Notification No.: 20130320

Description: TBV Intermittent Operation

Hardware: TBV-100 and TBV-101

Figure 1

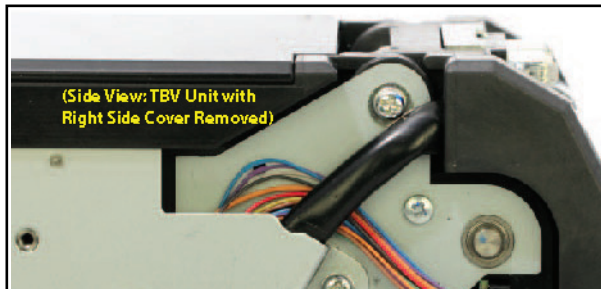
JCM Engineering has received field reports of TBV-100 and TBV-101 Transports exhibiting the following conditions: low acceptance rates, increased bill jams, and/or continuous cycling at power-up. After a detailed investigation, JCM Engineering identified a risk of possible damage to the Sensor (In-Down) PCB Harness during installation of the Right Side Cover on the TBV Unit. The wires can become pinched between the cover and the TBV frame (Figures 1 and 2).

If the TBV Unit is demonstrating the above error conditions, remove the Right Side Cover and examine the Sensor (In-Down) PCB Harness for damaged wires. The Harness should be replaced if damage is visible (replace with Sensor Harness 1 (ID), EDP Part Number 151467). To prevent further damage, use a tie wrap to secure the Sensor (In-Down) PCB Harness to the Sensor (Out-Up) PCB Harness, to move the Harnesses away from the cover mounting screw (Figure 3).
